# ADDENDUM NO. 3

### November 28, 2022

# JACKSON ELEMENTARY SCHOOL RENOVATIONS Valparaiso, IN 46304

This Addendum consists of page ADD 3-1 and attached Addendum No. 3 from Gibraltar Design dated November 23, 2022 and consisting of 7 pages and 42 drawings.

Tuesday, 11/22/2022 - 5:14 PM - LAST SAVED BY:JGRU Y:\21-143 DUNELAND SC - JACKSON ES ADDITIONS AND RENOVATIONS\21-143 DRAWINGS\05 ARCH\A-501.DWG

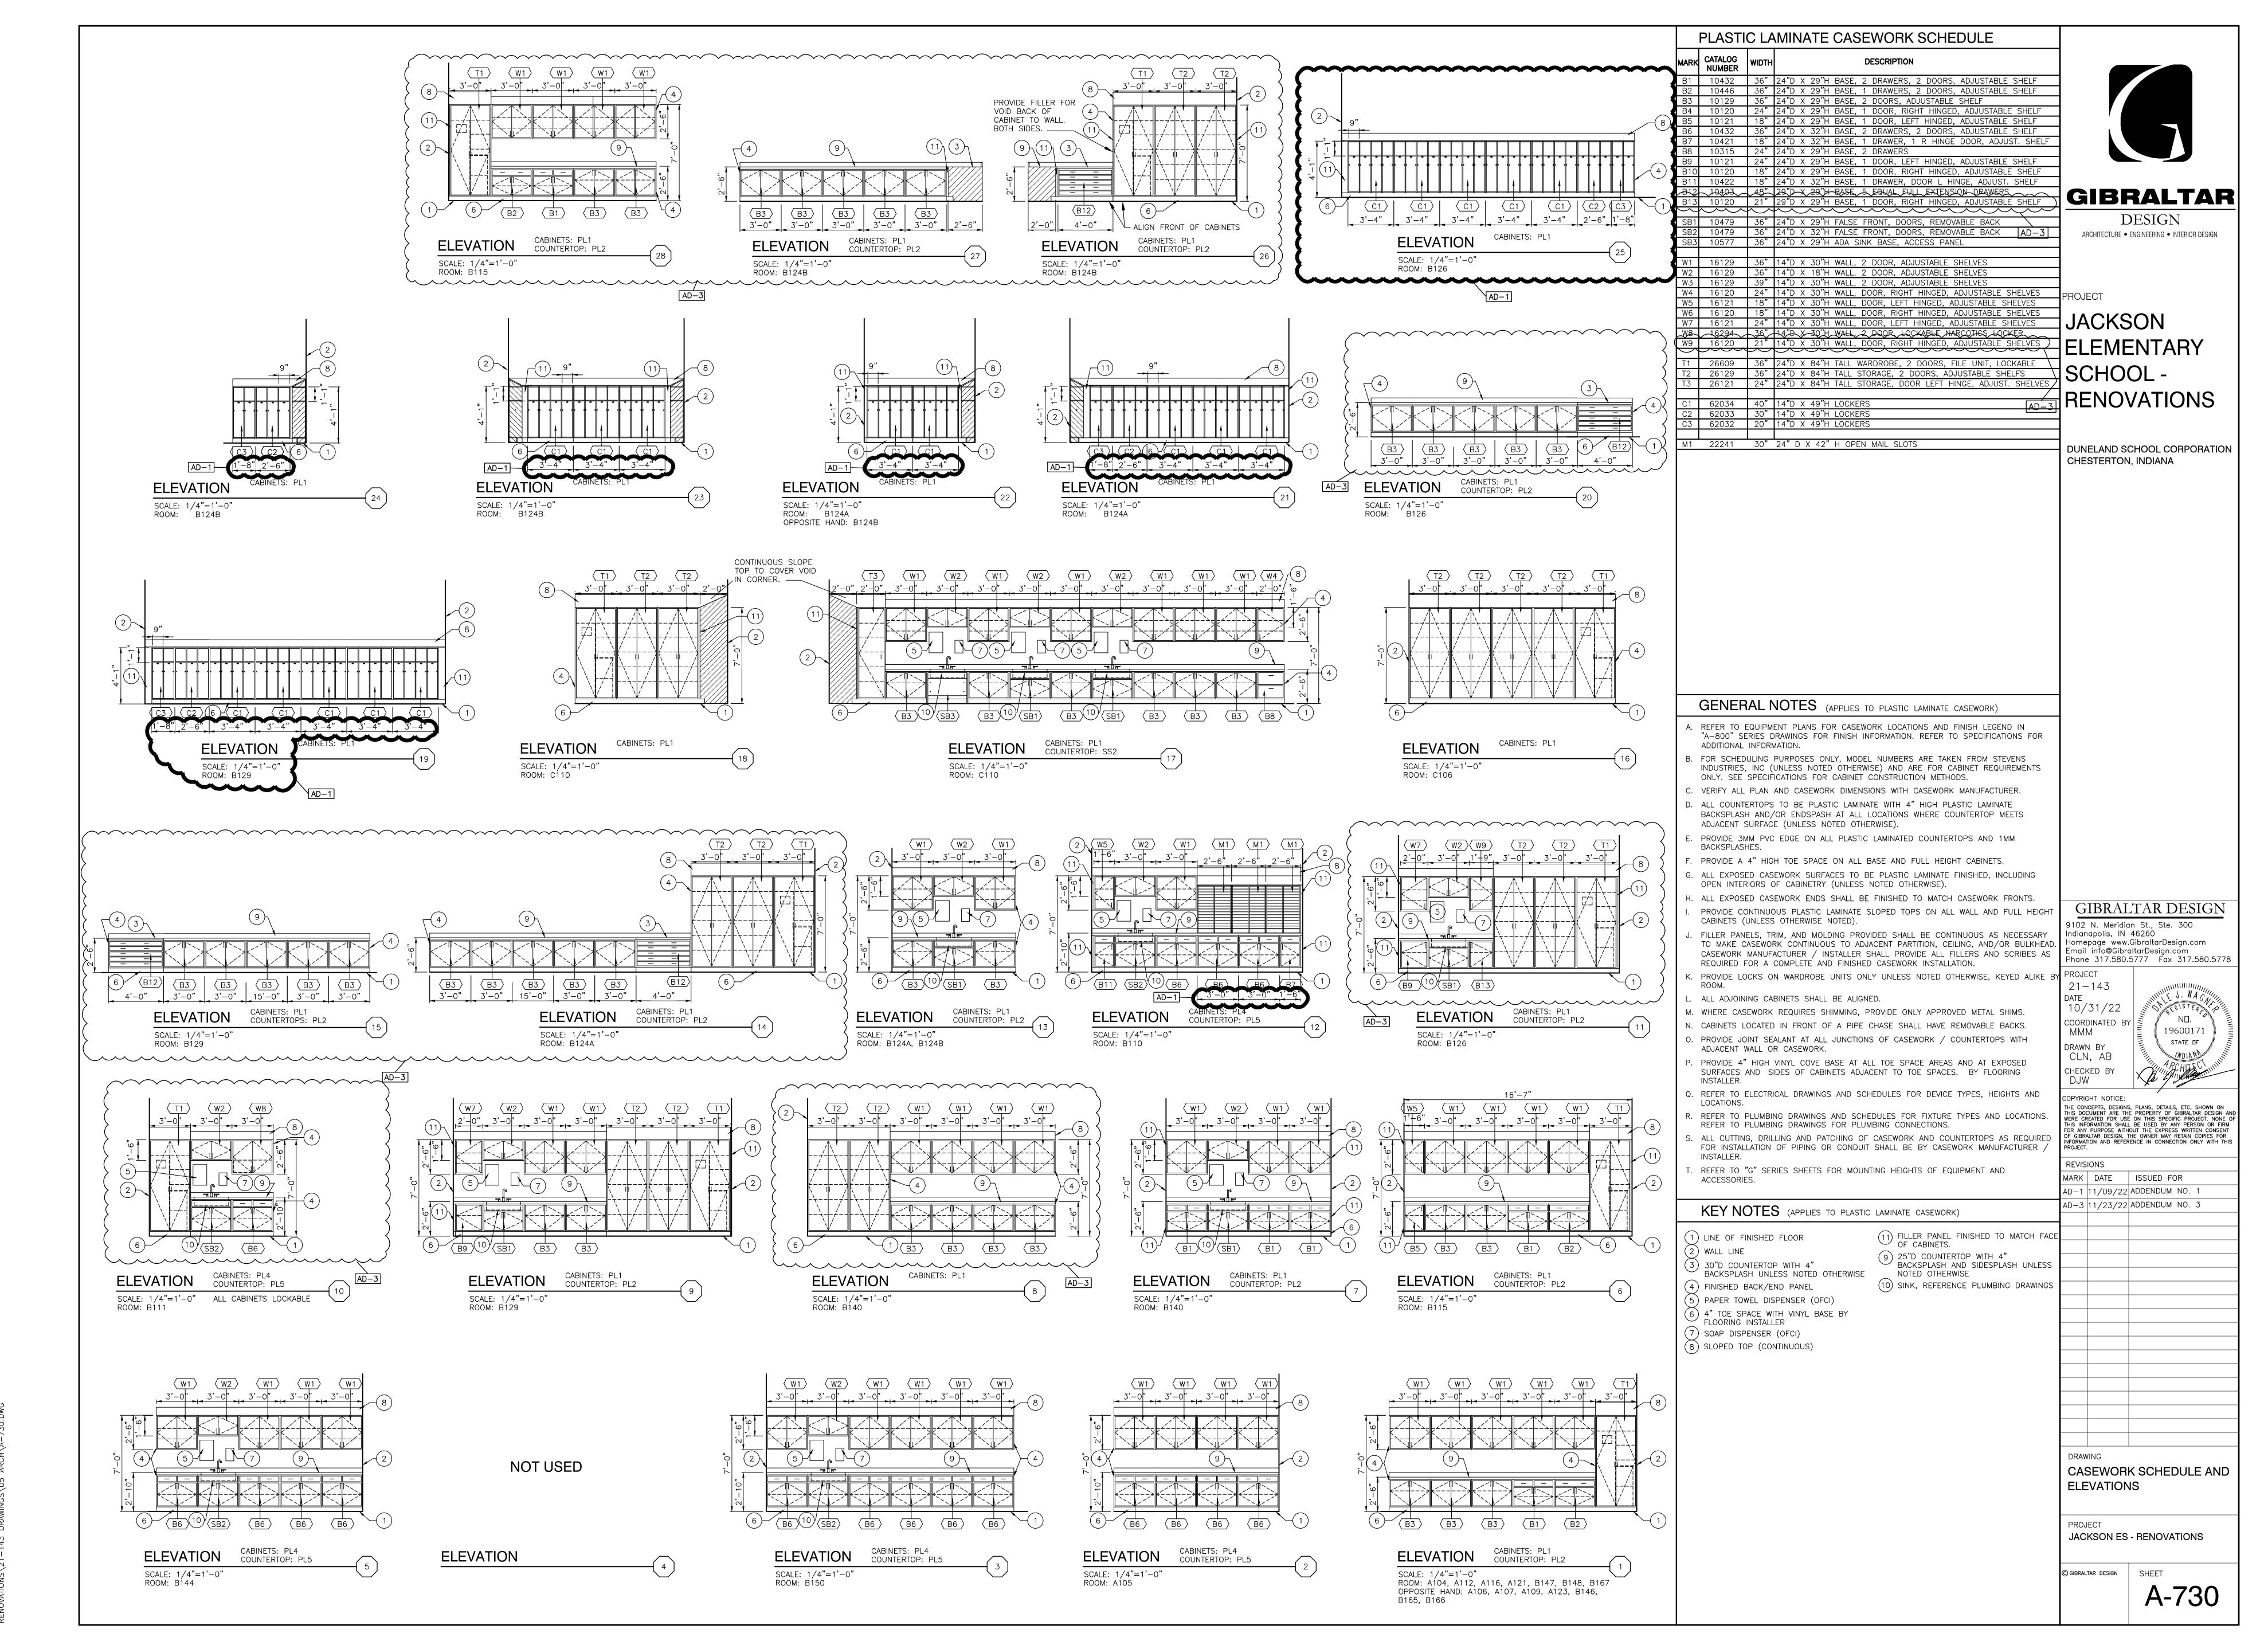
A. Refer to revised full size drawing, included in this Addendum, for revised locker size and count.

A-801

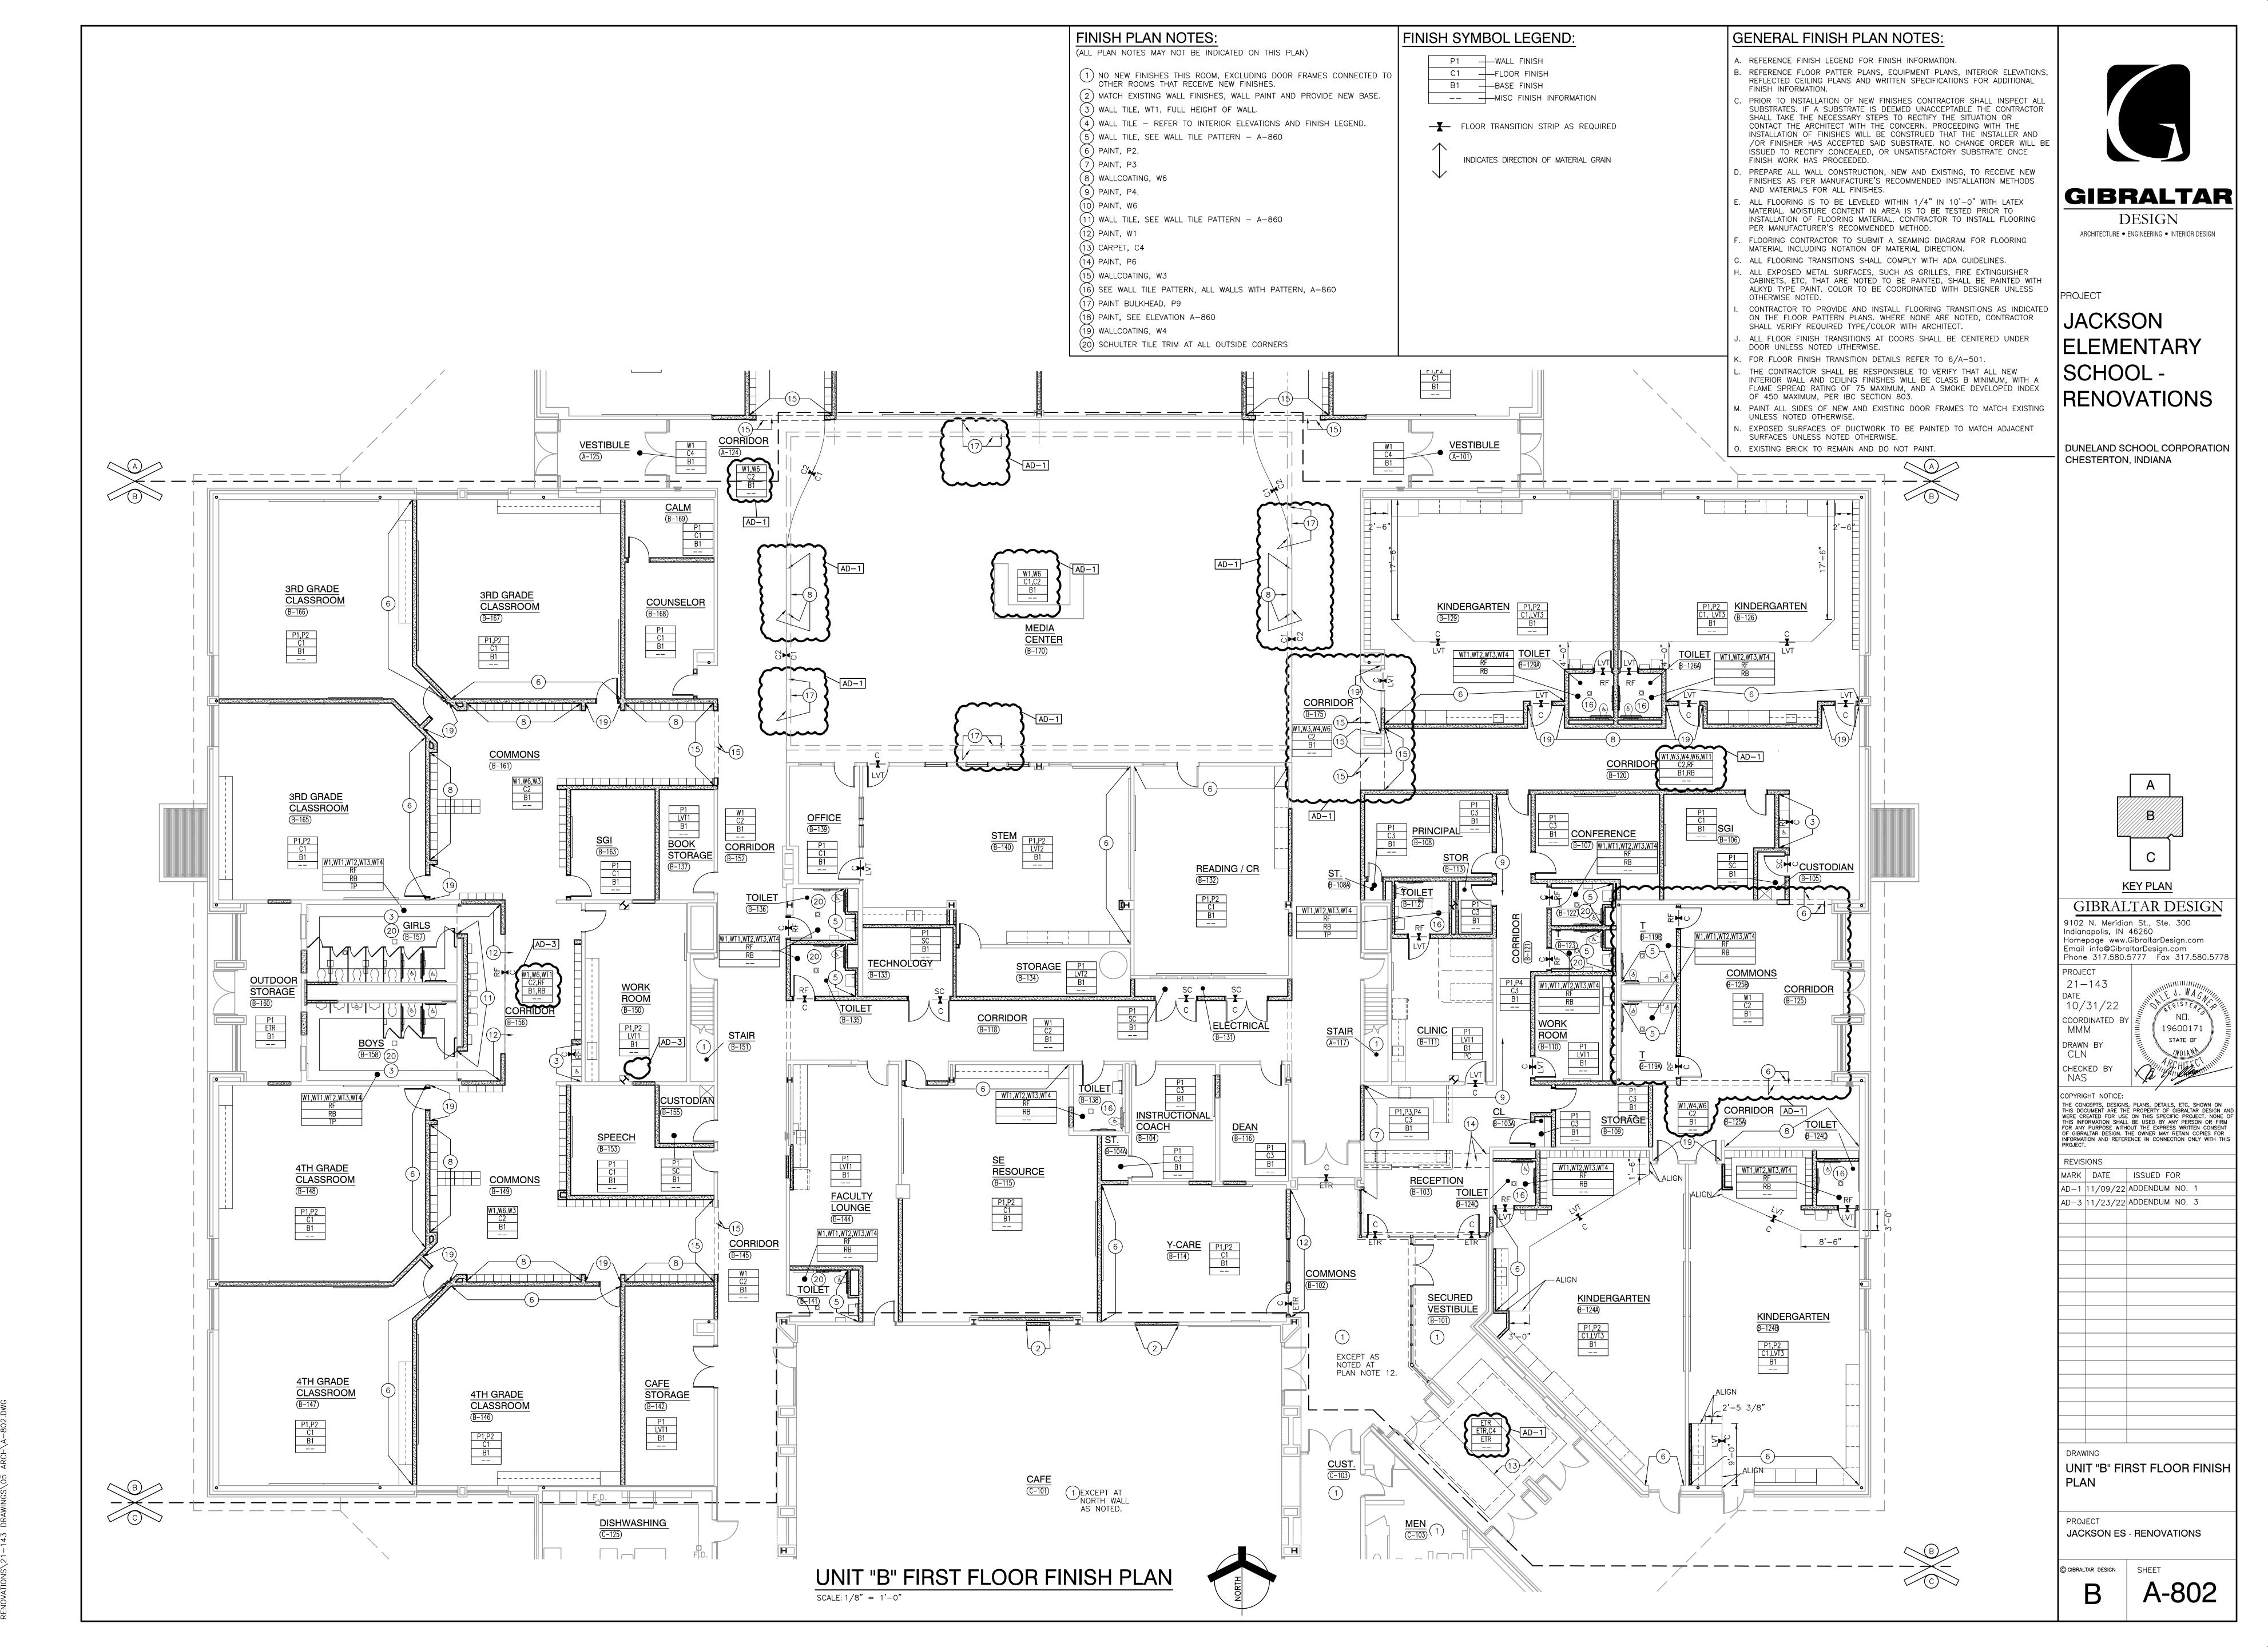
- A. Refer to two (2) revised full size drawings, included in this Addendum, for the following revisions:
  - 1. Note plan finish changes.

PD103

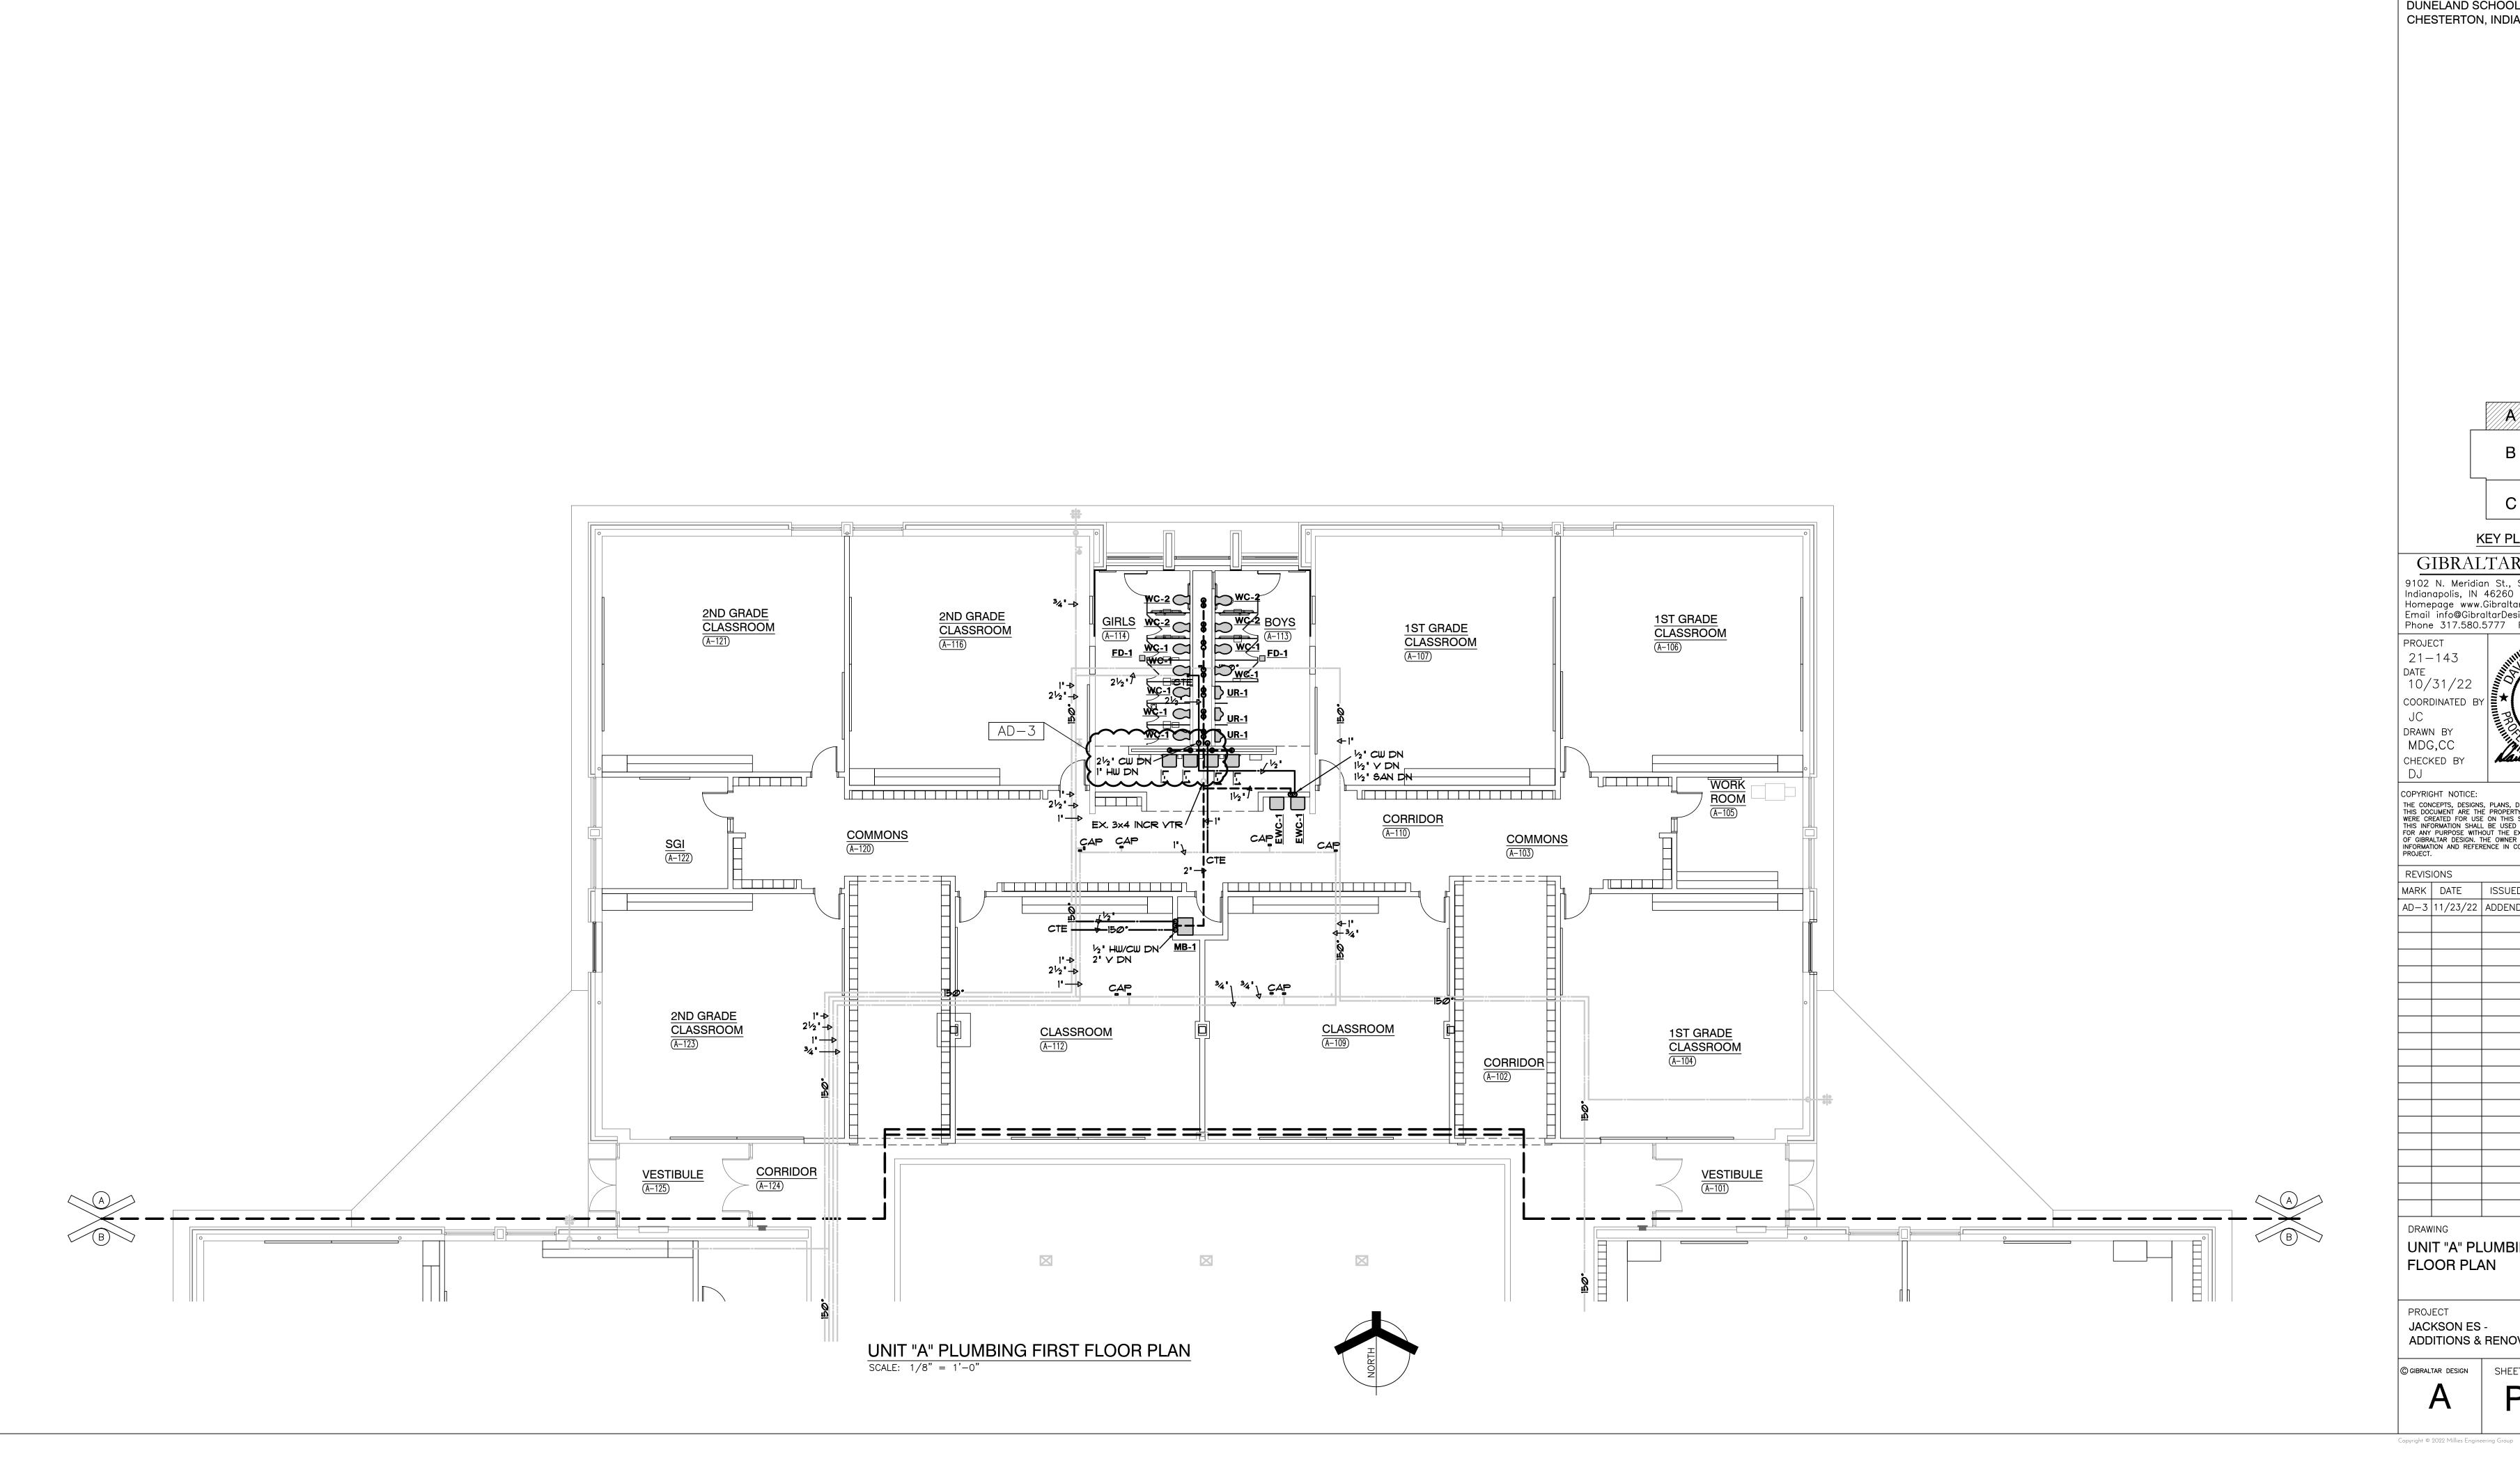
A. Refer to revised full size drawing, included in this Addendum, for clarification to existing sanitary piping.
